<b>CHANGE REQUEST NO. ILC-CR-00XX</b>	EDMS No: <b>D*</b>	Created: <b>xx/9/2017</b>
		Last modified: <b>xx/9/2017</b>

## LUMINOSITY IMPROVEMENT AT 250GEV CM

The luminosity at the center-of-mass energy 250GeV can be improved by factor  $\sim 1.65$  by adopting the horizontal emittance at IP factor 2 smaller than in the TDR. This is achieved by modifying the damping ring design slightly.

Fig.1. TDR (left) and new (right) layout of the arc cell and the optics.

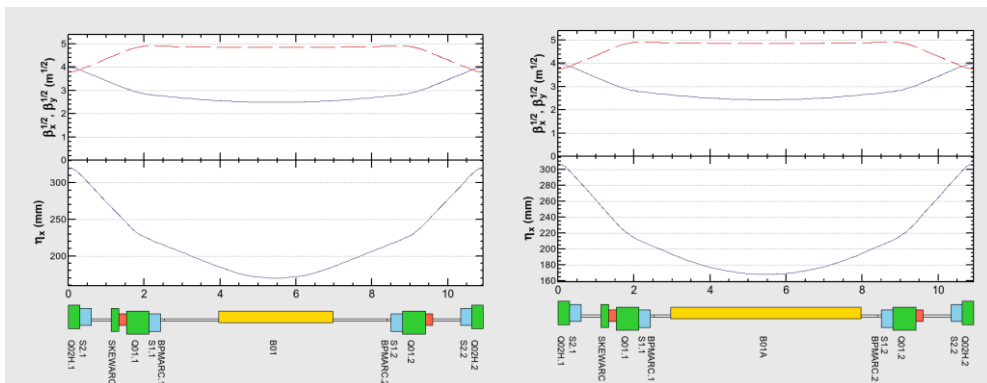
The layout of the arc cell in TDR DR contains 1.5m drift space between the dipole and quadrupole magnets. This space is reserved for the pillars to support the electron ring components lifted above the positron ring. It may be reduced to 0.5m by changing the design of the support so that the effective length of the dipoles is lengthened  $3\text{m} \rightarrow 5\text{m}$  (see Fig.1). (5m dipole will be split for actual construction).

The emittances and the damping times were computed by using SAD including the effects of intrabeam scattering (IBS) (see K. Kubo [1] for details). The new optics gives  $\epsilon_{x,n} \sim 4\mu\text{m}$ .

Fig.2. Dynamic aperture in the new design without errors

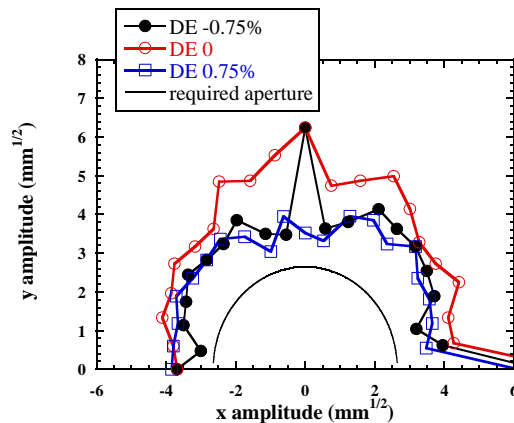
There are other possible choices of change, other than the longer bend even within the scheme of the so-called TME. However, the choice of stronger quadrupoles with the TDR magnet layout or the choice of increased number of arc cells do not give sufficiently wide dynamics aperture, though they give the required horizontal emittance. On the other hand, the present choice of longer dipoles gives sufficient aperture as shown in Fig.2. Degradation of aperture due to magnet errors has been checked and turned out not to be significant.

Fig.3. Luminosity ( $L_{\text{total}}$ ,  $L_{90\%}$ ,  $L_{95\%}$ ,  $L_{99\%}$ ) vs. beam vertical position error  $\Delta y$  for the 4 cases, TDR, (A), (B), and (C) (black, red, green, blue, respectively).

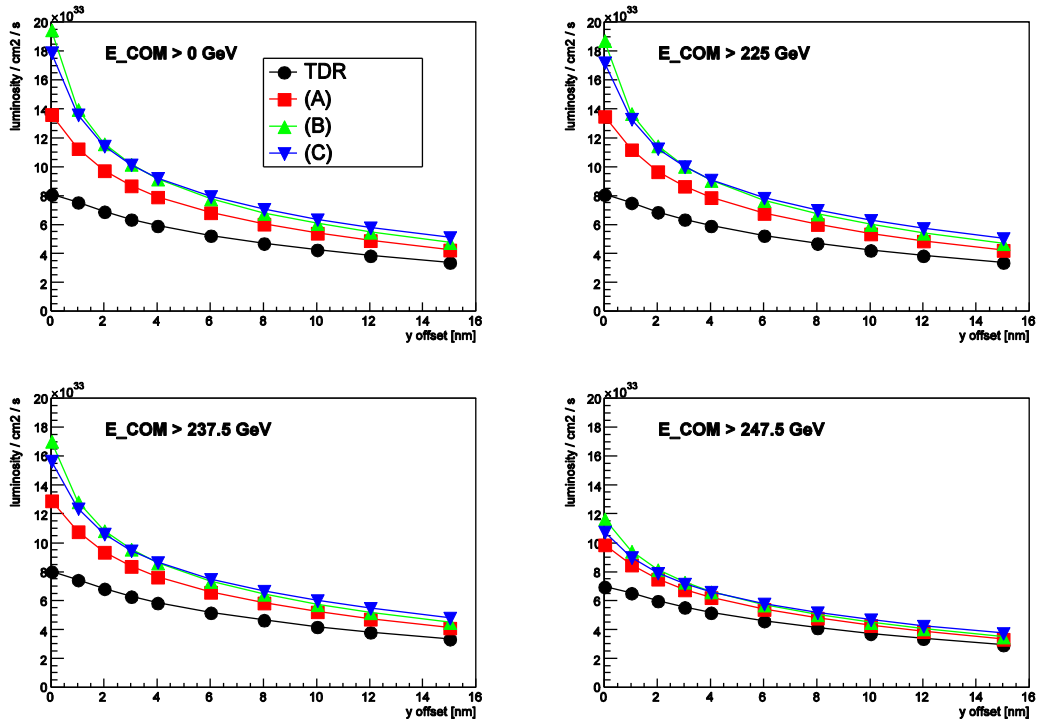
The vertical disruption parameter  $D_y$ , which is proportional to  $1/\sigma_x$ , increases from the TDR value  $\sim 25$  to  $\sim 35$  for (A) and (C), and to  $\sim 42$  for (B). The luminosity would be more sensitive to the vertical beam positioning error  $\Delta y$ . Fig.3 shows a simulation result.

The luminosity is more sensitive to  $\Delta y$  than TDR case as expected, but the tolerance of  $\Delta y$  in units of nm (not in  $\sigma_y$ ) is not tighter than at 500GeV (where  $\sigma_y$  is smaller). The simulation includes only parallel offset of the beam. More complex case such as slope ( $\Delta y$  linearly proportional to  $z$ ), banana shape (quadratic), etc. should later be examined.

Fig. 4. Beam-beam kick angle as a function of the vertical beam offset  $\Delta y$  for TDR (red) and (C) (blue).

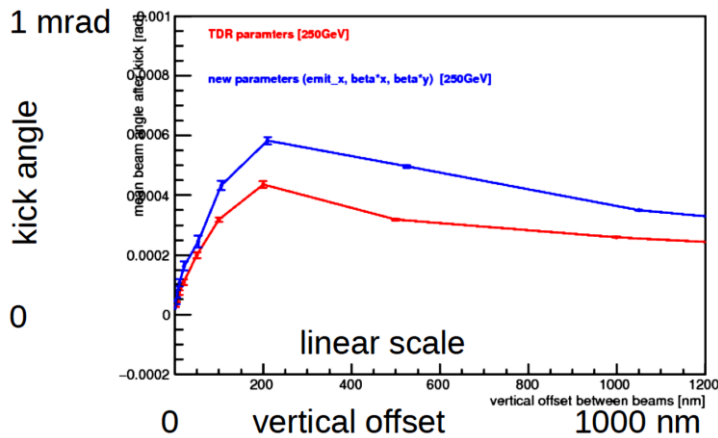
Fig.4 shows the beam-beam kick angle as a function of the vertical beam offset  $\Delta y$  for TDR and (C). The kick angle is obviously larger but the dynamic range of the feedback ( $\sim \Delta y$  at the peak of the kick) does not decrease.
